CITY OF WAUWATOSA

BOARD OF PUBLIC WORKS

Subject: **Request by Brian Sell, on behalf of JC Penney, 11800 W. Burleigh Street, for an exception to the 25' height limitation on private parking lot light poles**

JCPenny - Secured Parking Lot - 34' MH - 100%

Photometric Drawing - LED Option 2

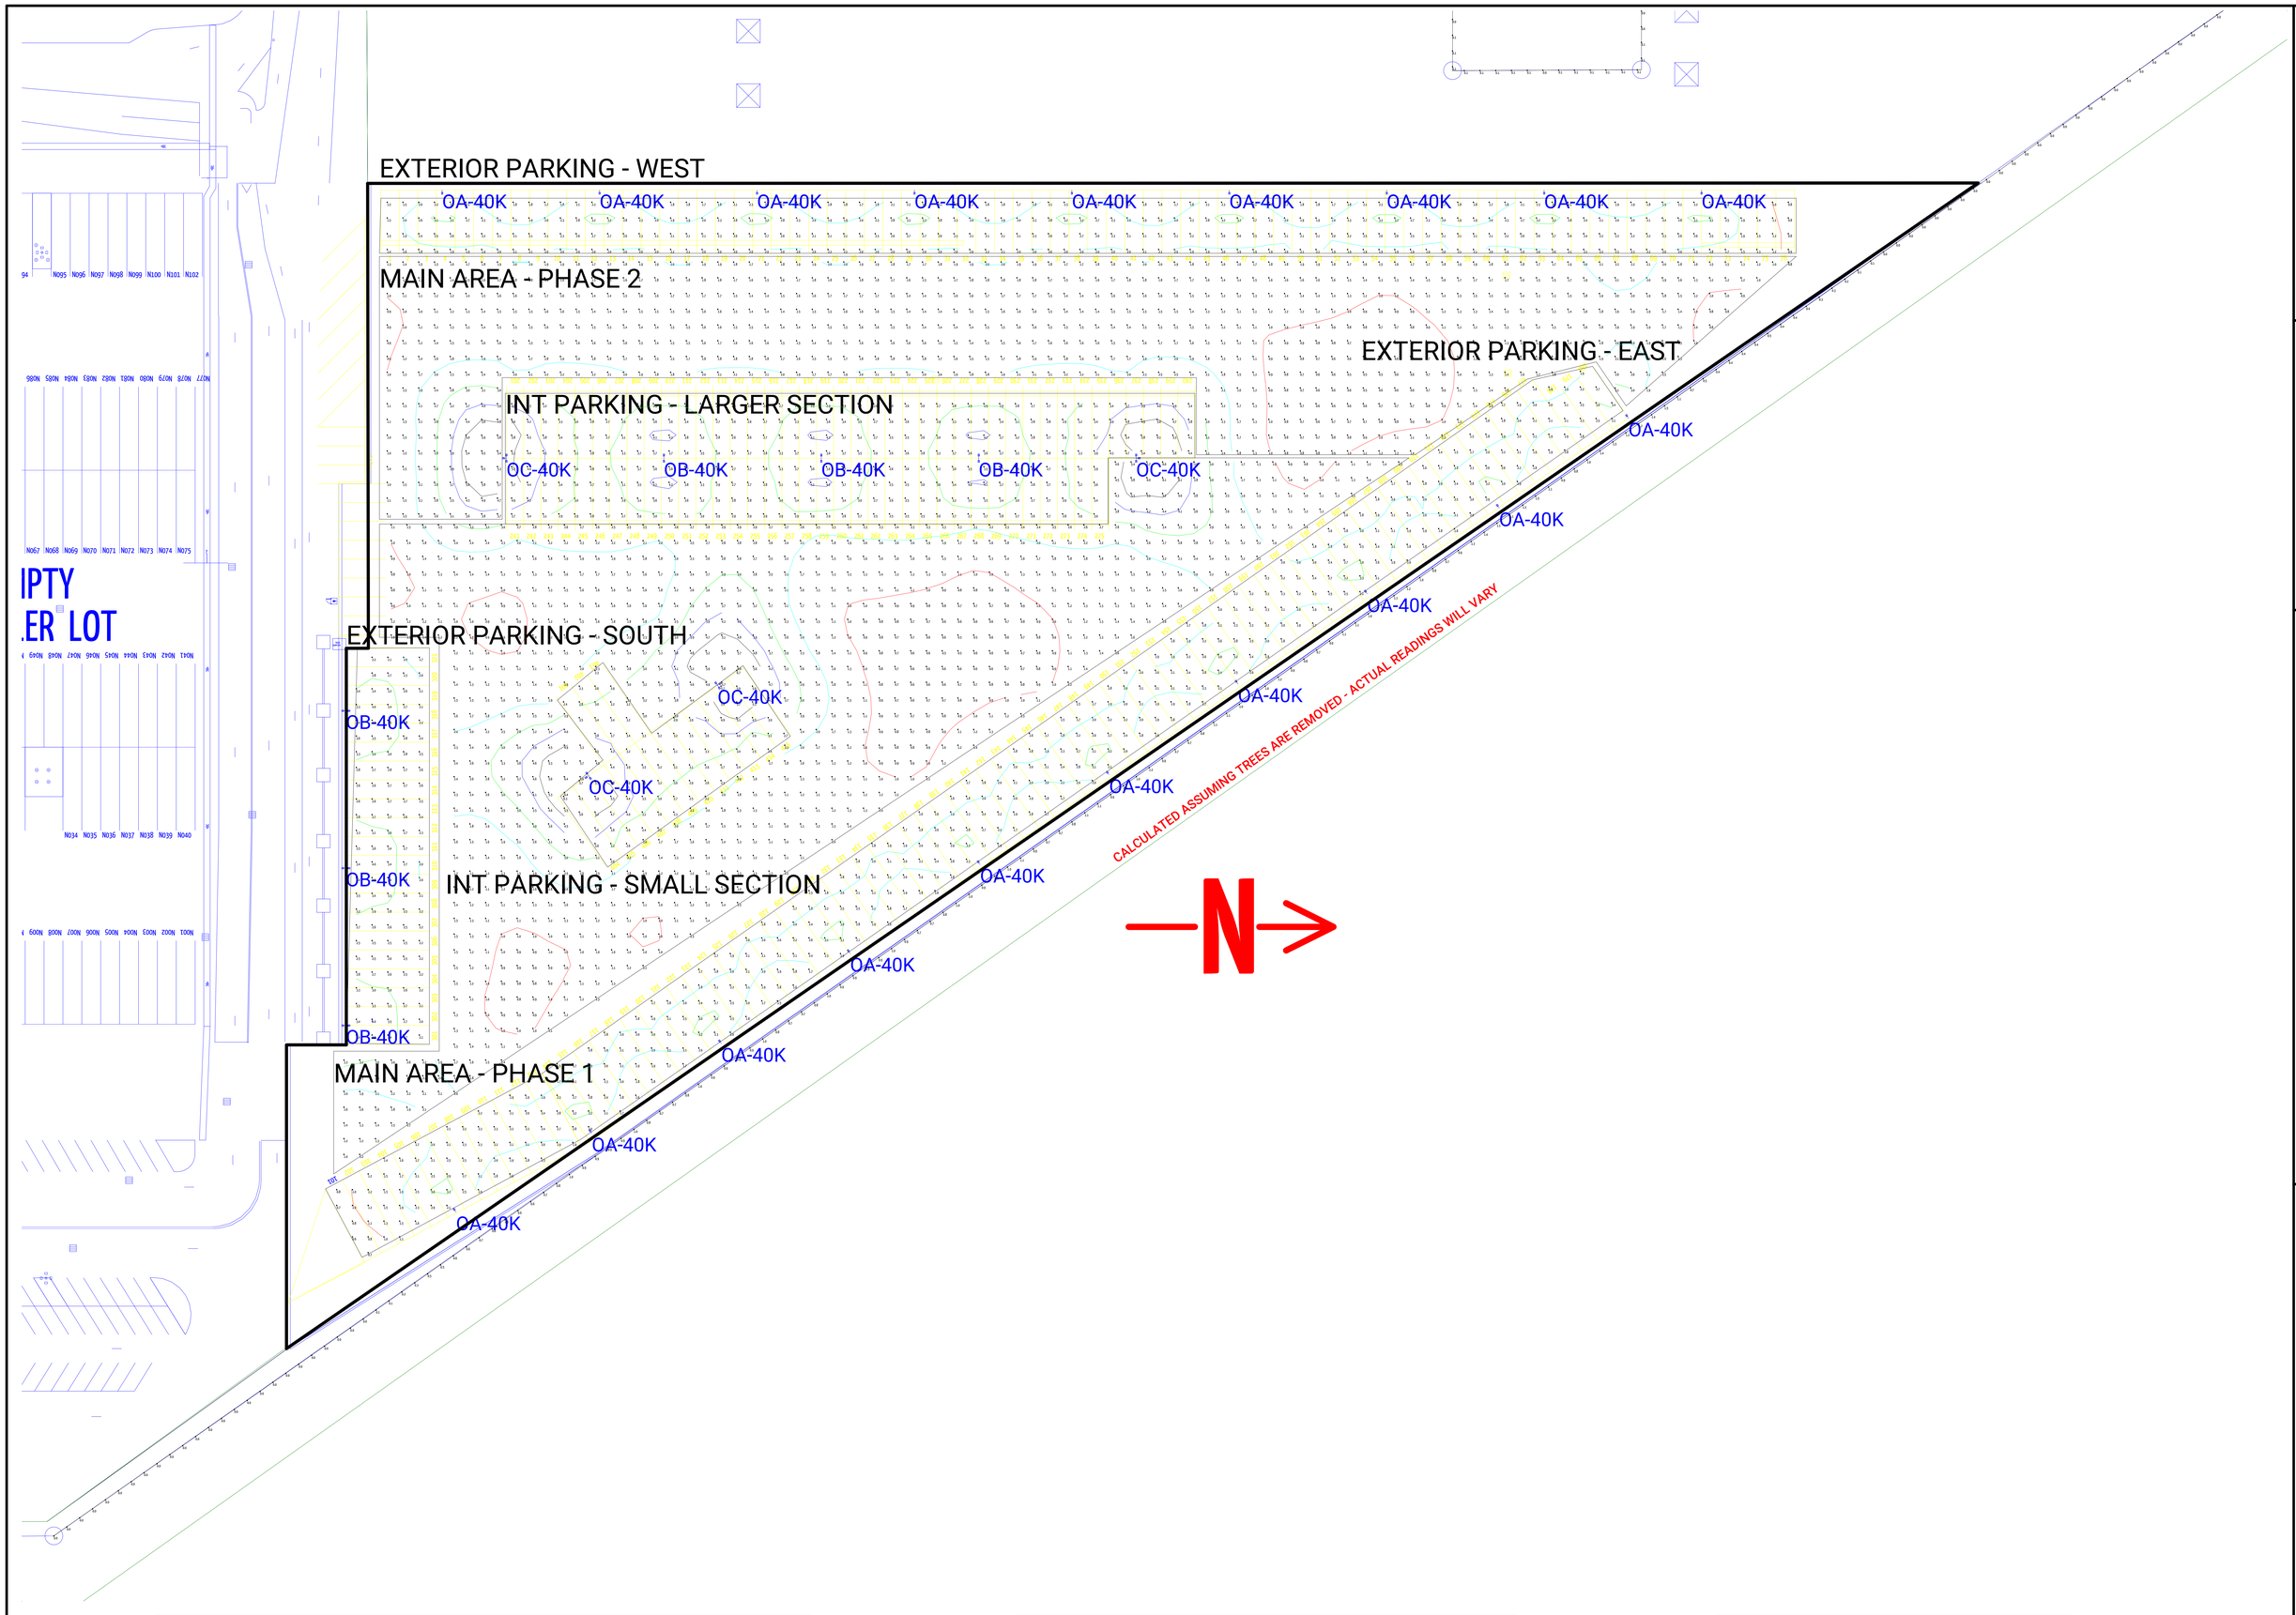
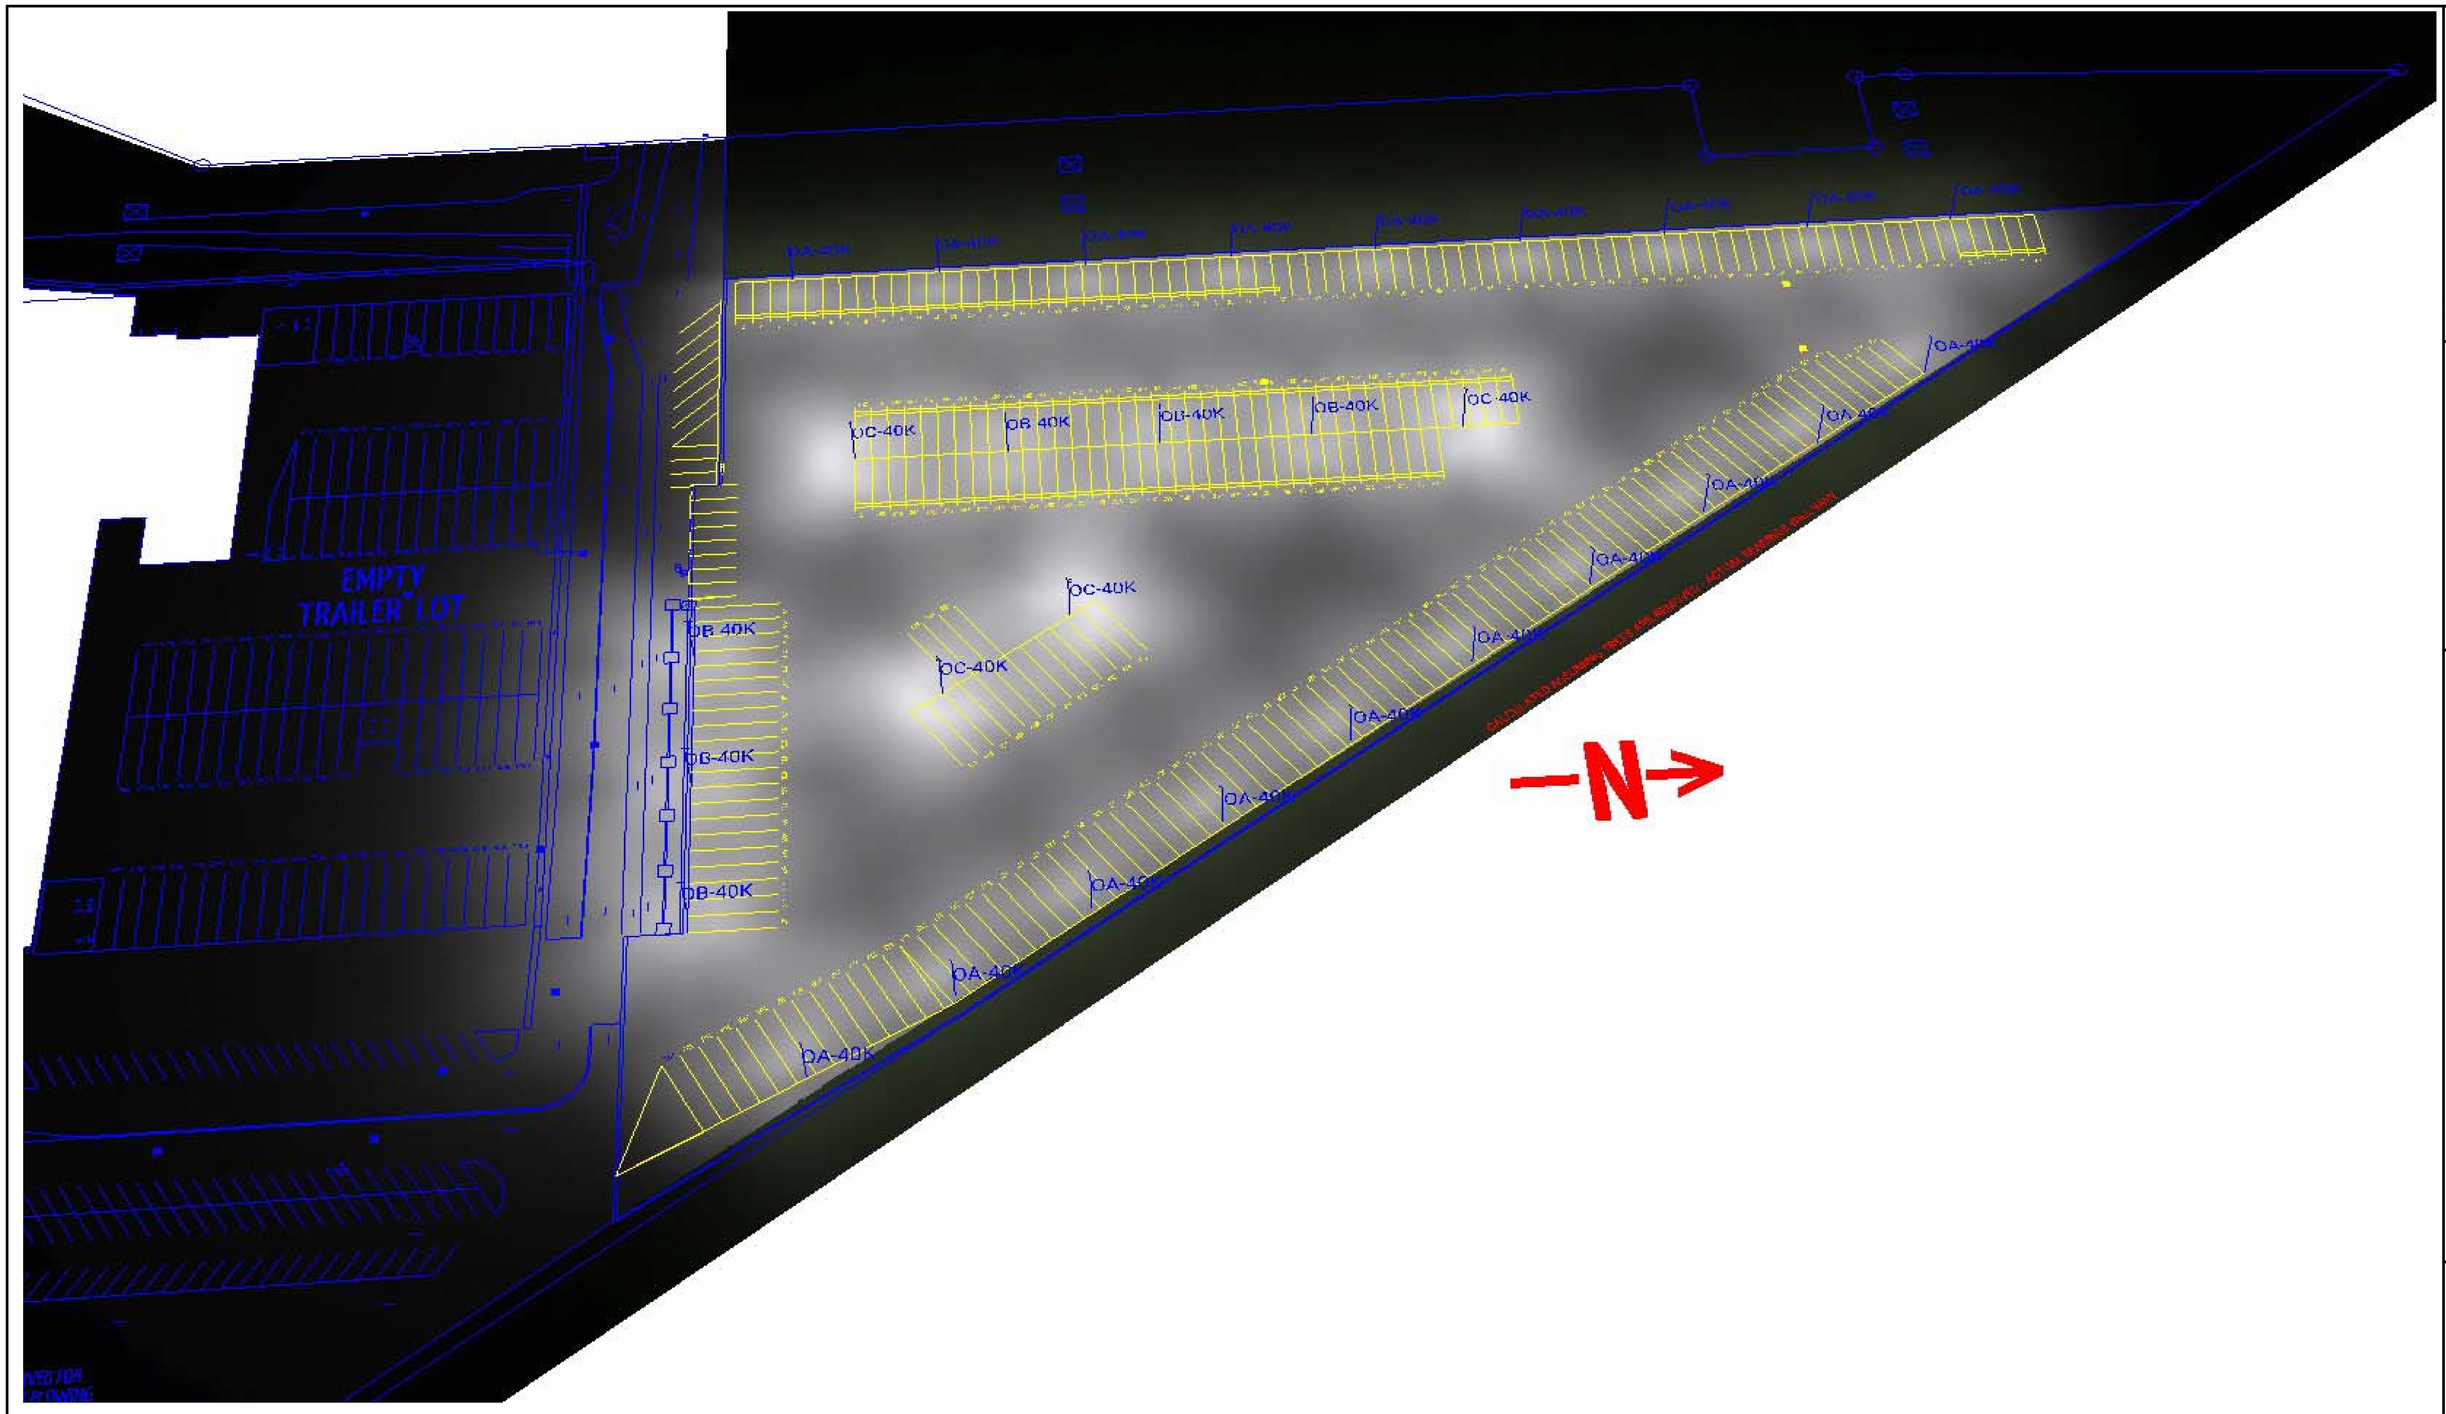
A. Issue
Proposed light poles exceed height limitation and illumination levels allowed in the code

B. Background/Discussion
JC Penney intends to install new parking lot lighting to improve security in the triangular truck parking lot located north of W. Wirth Street. The proposed Light Emitting Diode (LED) cut-off fixtures will be mounted on 30' high poles on 4' high bases. The total height of 34' exceeds the code requirement of a maximum 25 feet. The height is needed to ensure adequate light levels can be achieved over the top of the trailers that are parked in the spots. If smaller poles would be required, the fixtures will need to be installed at an upward angle to cast sufficient light into the lot. Fixtures angled upward would be more visible to passing motorists and could present a safety hazard.

The illumination levels along the east and west property lines also slightly exceed codes levels, however, cut off fixtures are used to minimize the level at the actual property lines versus in the parking lot 10' off the lot line. Railroad right-of-way and a grassed easement area for high tension towers are the two adjacent land uses to the parking lot.

The lighting design will also incorporate a system to dim the lights to 50% of the proposed illumination level after a set time period. The period will be long enough for a trailer to be parked and the cab to exit the parking lot.

D. Recommendation
1. Approve the lighting plan as presented.
